# TECHNICAL EVALUATION REPORT

## ASSESSMENT OF THE DESIGN OF THE CRESCENT JUNCTION DISPOSAL CELL COVER

S&K MOAB TAC TEAM

**March 31, 2010**

Figure 2: Disposal Cell Edge Showing Potential Insufficient Radon Barrier Thickness

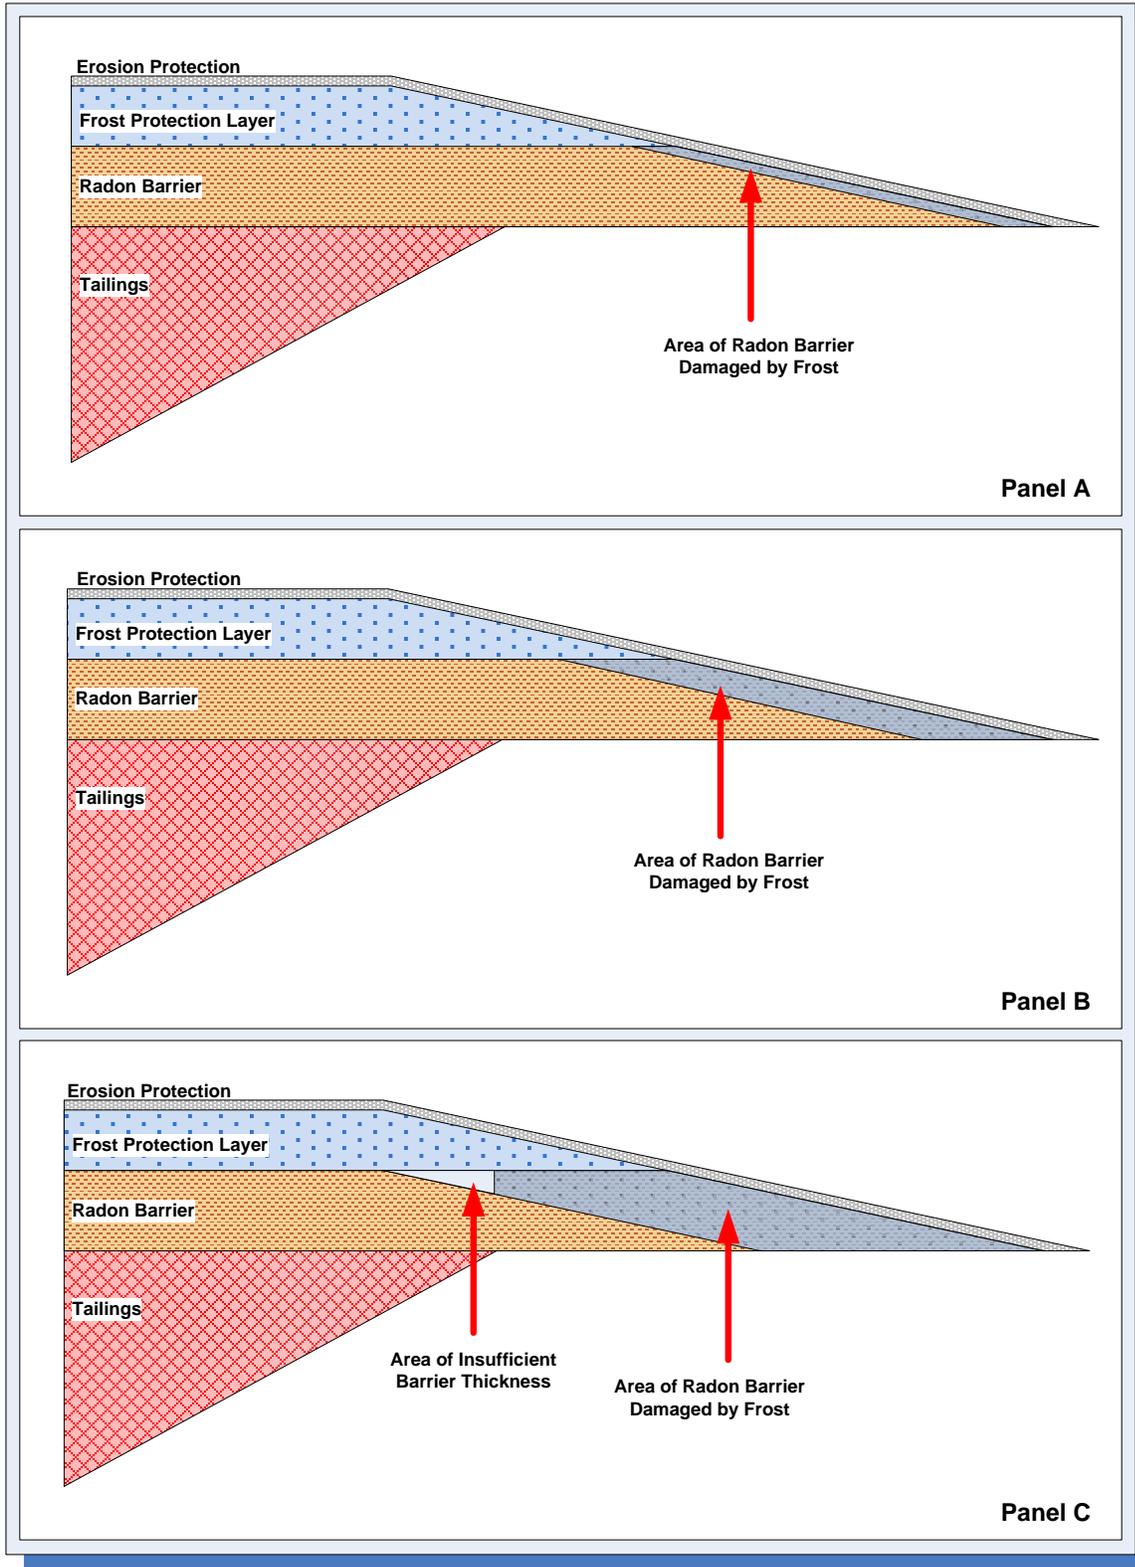
This does not mean, however, that the thinner frost protection layer can be ignored. The frost protection layer over the disposal cell was set at 36 inches to provide protection to the radon barrier from seasonal freeze and thaw cycles. If the radon barrier is allowed to repeatedly freeze and thaw, its bulk density could be reduced and cracks and fissures could form ([DOE, 2008](#)). These changes could decrease the barrier's ability to limit the diffusion of radon gas. At the time of disposal, since no frost damage to the radon barrier has occurred, the thinner frost protection layer would not affect the ability of the radon barrier to meet the release limit. However, if the radon barrier at the edge did crack, fissure, or reduce in bulk density, the radon release rate at the edge could increase over time. The potential extent of frost damage to the radon barrier, and resulting region of insufficient barrier thickness, is illustrated in [Figure 2](#).

This decrease in frost protection thickness has raised concerns as to whether or not the edges of the disposal cell provide the required attenuation of radon gas. As a potential worst case scenario, Jacobs Engineering assumed that any portion of radon barrier material within 36 inches of the erosion protection layer would be lost due to frost damage. They then used the NRC's RADON program to calculate the radon flux at various locations along the edge of the disposal cell ([Jacobs Engineering, 2009](#)). The edge design considered by Jacobs Engineering, and a graph of the resulting calculations, are shown in [Figure 3](#) and [Figure 4](#).

Figure 4: Radon Flux at Disposal Cell Edge ([Jacobs Engineering, 2009](#))

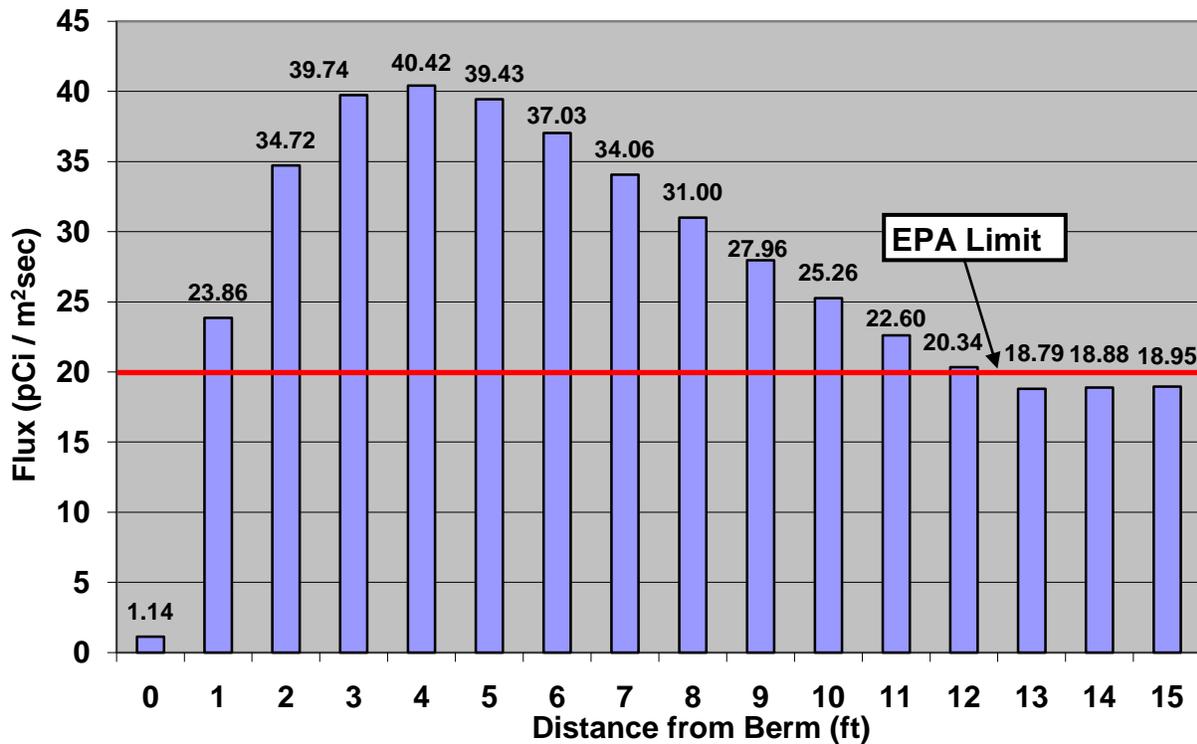
As [Figure 4](#) shows, frost damage to the radon barrier material could result in local radon fluence from the cover near the disposal cell edge exceeding the 20 pCi/m<sup>2</sup>s limit. Still, even if the cover does not provide the required amount of attenuation at the disposal cell edge, the ability of the site to conform to the required radon flux should not be affected.

The regulation defines the disposal site to be the region inside the perimeter of residual radioactive material following the completion of control activities (EPA, 2005). By this regulatory requirement, if it can be shown that the cover design's average radon release rate over the entire disposal cell after completion does not exceed the limit, then higher localized release rates over the edges would be insignificant and permissible. The insufficient radon barrier thickness applies to a strip of the cover 14.3 feet wide and 2400 feet long over parts of the south and west edges of the disposal cell. As shown in Figure 5, the area of the disposal cell edge with insufficient thickness represents a minimal portion of the entire cover area, about 0.4%. Since the affected area is so small, the higher radon flux above the cover in this area should easily be compensated for by the lower radon flux over the remainder of the disposal cell. Thus, a calculation that accounts for the potential reduction in radon barrier effectiveness due to frost damage, but still shows overall disposal cell compliance with the EPA standard, would satisfy NRC requirements without design modifications or constructed revisions.

**Figure 6: Top View of Affected Portion of Disposal Cell Cover**

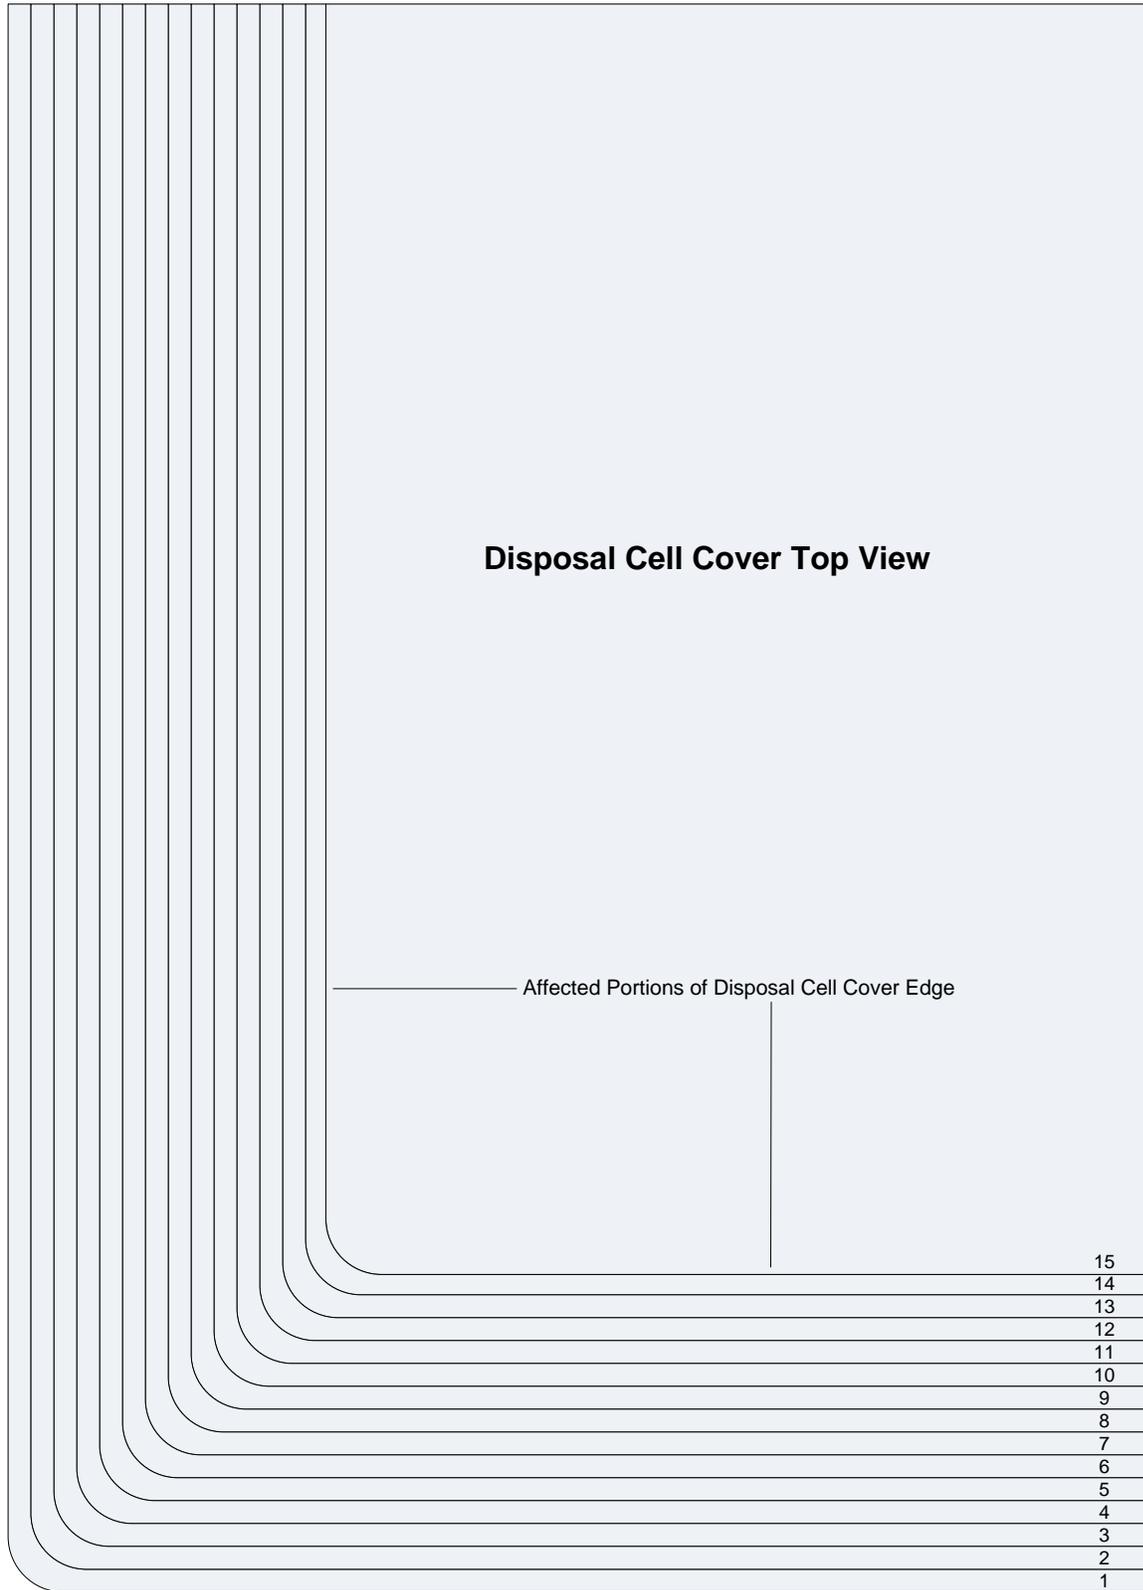
[Figure 6](#) shows the top view (plan view) of the portion of the disposal cell edges along the west and south edges that are affected by the design flaw. For the purpose of performing calculations, the edges have been split up into one foot wide strips to match the work that Jacobs Engineering did, shown in [Figure 3](#) and [Figure 4](#). Since the flaw is known to affect the first 1400 feet of the west edge and the first 1000 feet of the south edge, the area of each L-shaped strip, shown in [Figure 6](#), can be easily calculated. These areas can then be multiplied by the modeled radon fluxes ( $\text{pCi}/\text{m}^2\text{s}$ ), shown in [Figure 4](#), to find the total radon release rate over that portion of the cover in picocuries per second ( $\text{pCi}/\text{s}$ ).

This calculation assumes that the future placement of tailings at the disposal cell edge is modified so that the design flaw in the frost protection layer is limited to the first 1400 feet of the west edge and 1000 feet of the south edge. Instead of following the initial design, the tailings should be placed in such a way that, even if frost damage to the radon barrier material occurs, the local radon flux at the disposal cell edge does not exceed the radon flux modeled over the bulk of the disposal cell (18.95  $\text{pCi}/\text{m}^2\text{s}$ ). If the tailings are placed in such a way that the local radon fluxes at the disposal cell edge are less than 18.95  $\text{pCi}/\text{m}^2\text{s}$ , then this calculation would overestimate the designed average radon flux over the entire disposal cell.

As [Table 1](#) shows, even though the local radon flux reaches over 40 pCi/m<sup>2</sup>s over small portions of the disposal cell edge, the relatively small area affected by this higher flux is insignificant compared to the rest of the disposal cell. Even with the design flaw at the disposal cell edge, the designed average radon flux is still 18.99 pCi/m<sup>2</sup>s. Thus, no changes to the disposal cell design are necessary to meet the EPA's regulatory requirement of 20 pCi/m<sup>2</sup>s for the average radon flux over the entire surface of the disposal cell.
